MANDATORY BULLETIN
No BE-058/SZD-50-3/2006 „PUCHACZ”

DESIGNATION-TYPE/MODEL: SZD-50-3 „Puchacz”

CONCERNS: Inspection of the rudder bottom hinge and revision to the Technical Service Manual

Fig. A

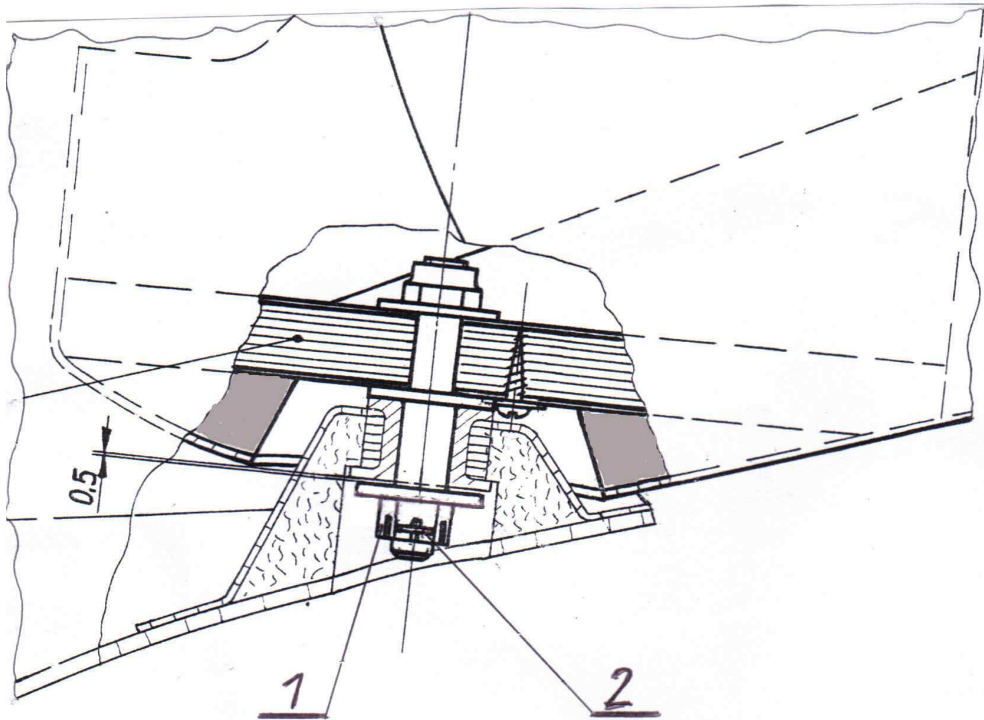
- 4.1 , Check by visual inspection the nut securing the lower hinge – see Fig. A. This one must be of the hexagon, castellated model (1) with the visible cotter pin (2).
- 4.2 In case of nut different from this one specified under item 4.1, proceed as follows:
 - undo the nut,
 - disassemble the rudder from hinges,
 - clean the opening for a cotter pin, one located in the bottom, threaded portion of the rudder pin,
 - grease the hinge bolts 14 and 15, as well as the pins 16 – Technical Service Manual, Fig. 8 or 7/2 (see item 4.3),
 - re-assemble the rudder on a vertical fin,
 - install the 6 mm diameter, 1.5 mm thick steel washer
 - screw on the M6 aircraft thin, castellated nut
 - install the 1.6 mm diameter cotter pin

Fig. B

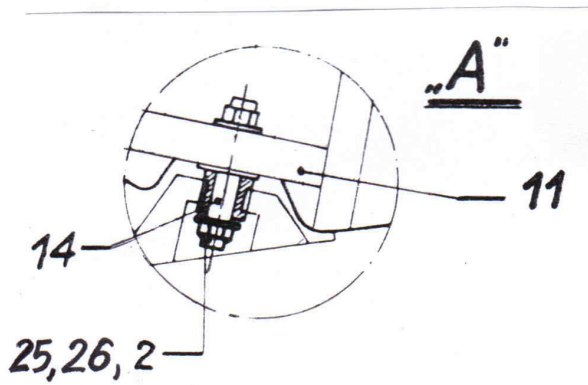
- in item 2.1 "Disassembling and assembling of rudder" replace the first portion of the sentence " For disassembling remove the self-locking nut 2" with "For disassembling remove the cotter pin 26, unscrew the castellated nut 2",
- in the legend to Fig. 8 – Rudder control system and assembly
 - in item 2 cancel the word "self-locking" and insert "castellated"
 - add item "25 – washer"
 - add item "26 – cotter pin"
- in the detail "A", Fig. 8, side to the reference 2 add 25 and 26 (see Fig. B of the Bulletin)
